CERTIFICATE OF APPROPRIATENESS

RE: Application Number 20-6662; 677 W. Canfield; West Canfield Historic District

Historical District Committee Restoration Review

Front Elevation (4 of 16) – Siding & Trim:

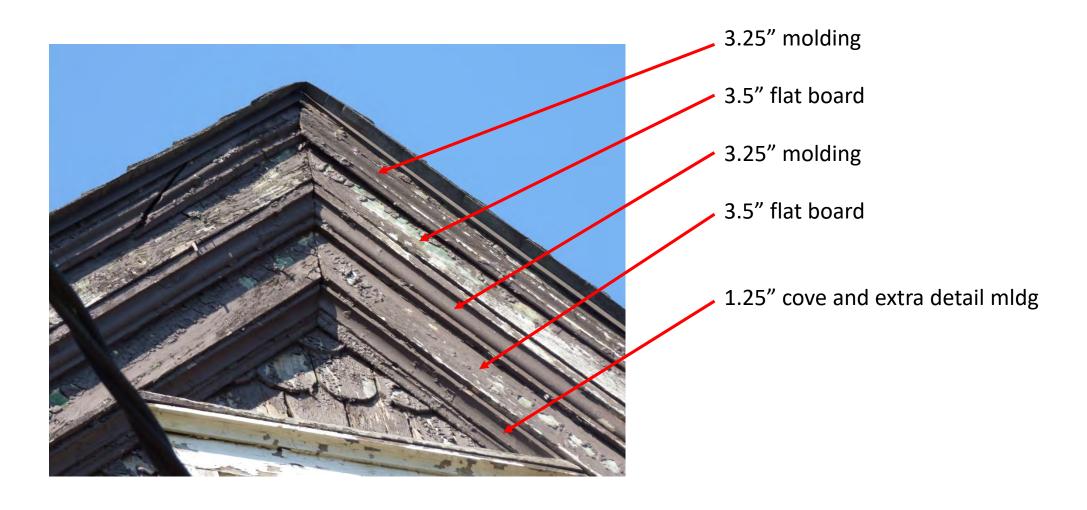
Remove and re-built with matching profile (see next page) to match rest of home repairs (approx. 20 lf)

Remove and replace gable siding with new scallop

siding

Remove and replace wall siding with new scallop siding keep mitered corner and flare out details Remove and bay siding with new scallop siding (to make consistency with rest of house and remove mismatched bevel cut siding

Front Elevation (8 of 16) – Window Surrounds:

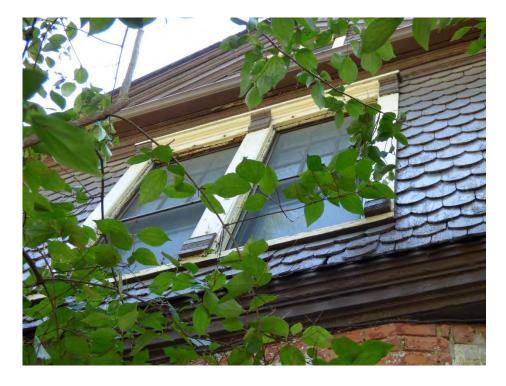
Remove and replace top ¾" thick cap with new ¾" thick smooth wood painted trim color

Remove 5/4x6 flat stock sides and header and replace with new 5/4x6 flat stock smooth boards painted trim color.

Remove strip and reinstall crown piece and paint trim color.

Front Elevation (11 of 16) – Window Surrounds:

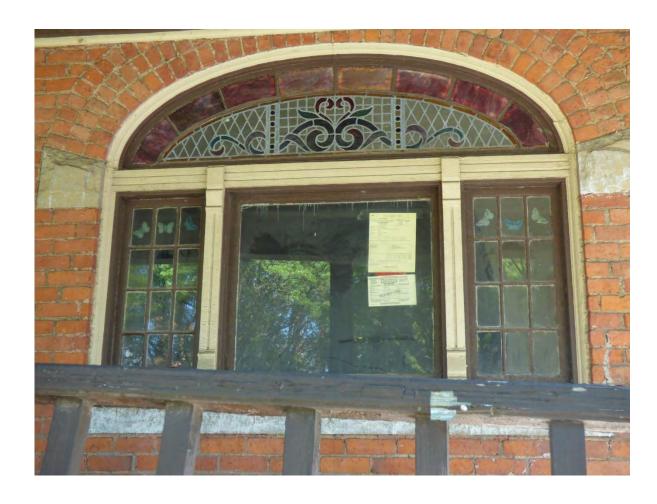
Remove, strip and reinstall plinth blocks and paint trim color

Repaired or new smooth cedar sill painted trim color with matching profile to existing sill

Front Elevation (16 of 16) – Front Porch:

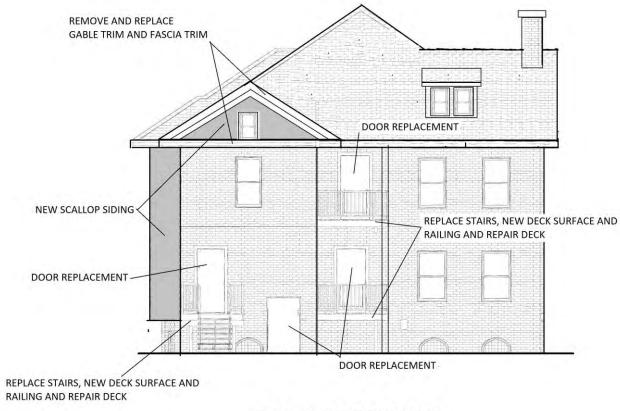
Remove and replace railing and balusters with cedar painted wood matching existing profiles and dimensions, but spacing updated to current building code requirements.

4" minimum spacing

Rear Elevation (2 of 7):

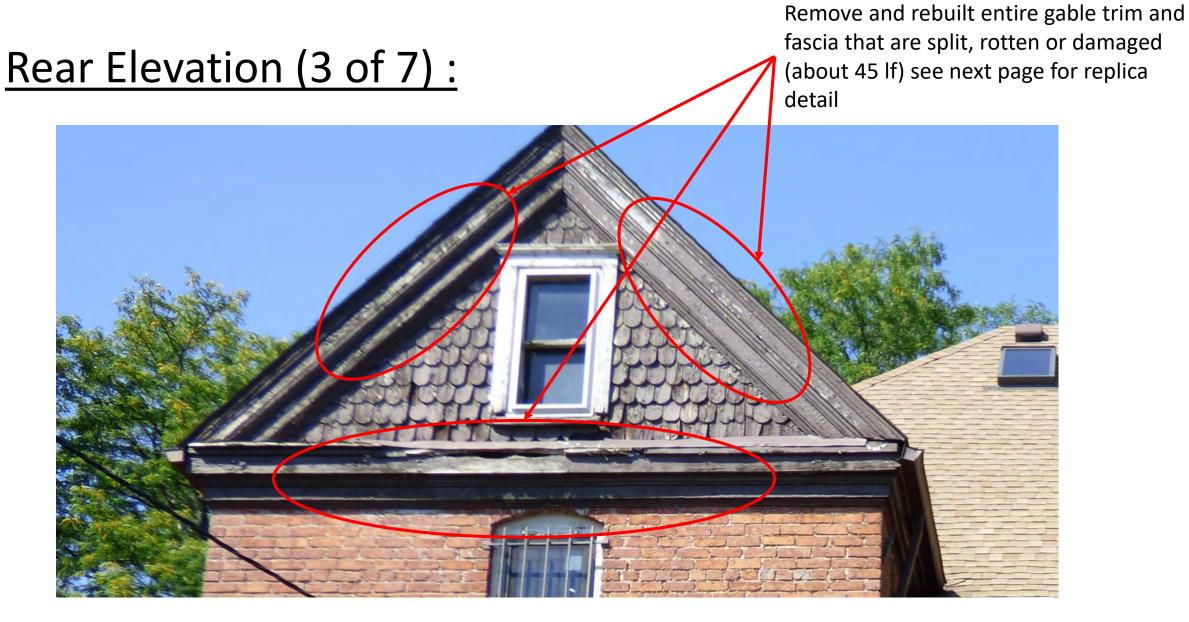
Proposed Rear Door Replacements
< all four >
(Color to Match the Front Door)

Existing Front Door (color to remain)

Rear Elevation (4 of 7) - Gable Trim:

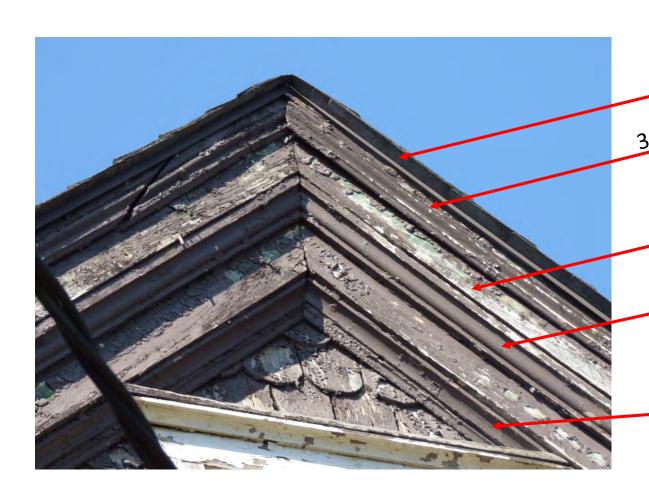
Drip edge trim 3.25" shingle mldg Flat molding 1.75" barge mldg Cove & bead molding

New molding profile

Rear Elevation (5 of 7):

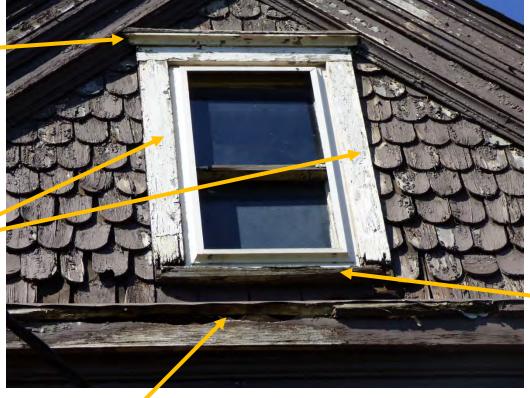
Existing 2" cove crown to be replaced with matching 2" smooth wood cove molding

Existing 5/4x4 casing and header to be replaced with new 5/4x4 flat stock smooth wood painted B:19 Black.

Remove and replace siding with new siding consistent with rest of home replacements

Existing 1.5" thick sill to be replaced with new 1.5" thick beveled washed cedar sill (cut to same profile)

Rotten Fascia Boards

Rear Elevation (6 of 7):

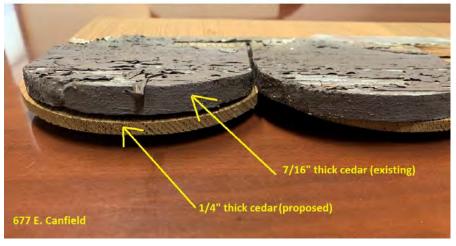
Existing painted wood

Proposed: cedar shingle siding >>>

Rear Elevation (7 of 7):

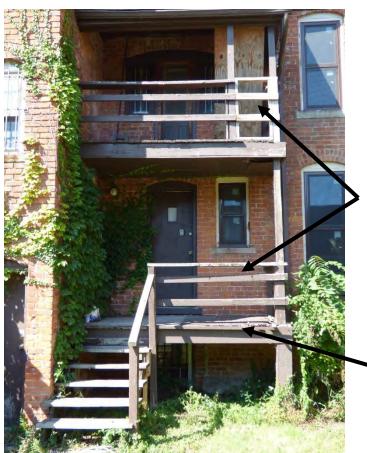
Remove stairs and railings on both rear decks and rebuilt to current building code.
Railing to match front porch railing system out of smooth cedar (painted)

New deck surface to match Front Porch – 1x4 smooth painted cedar Repair any deteriorated structural members or replace with exact dimensional match.

Right Elevation (2 of 4):

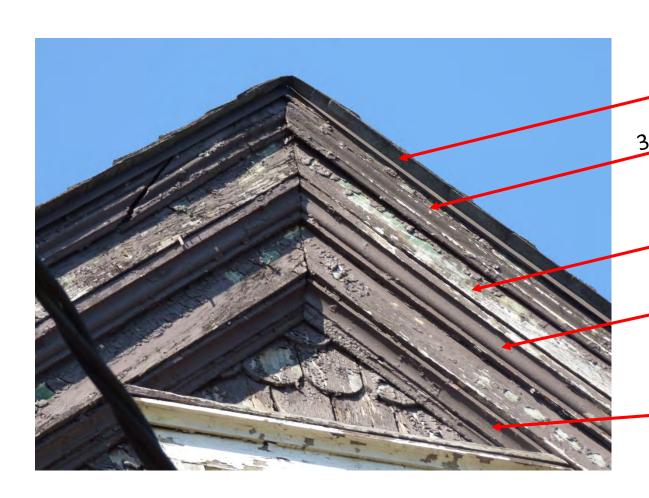
Remove and replace with new trim gable trim, approx. 11ft long on each side of chimney and siding (some rot and splitting)

Remove and replace with new trim approx. 8ft long on each side of chimney (rotten and deteriorated)

Right Elevation (4 of 4):

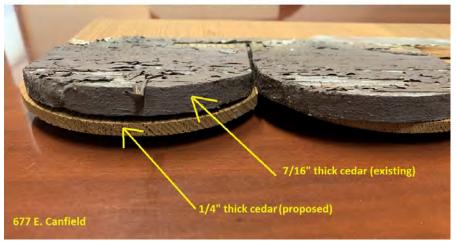
Existing painted wood

Proposed: cedar shingle siding >>>
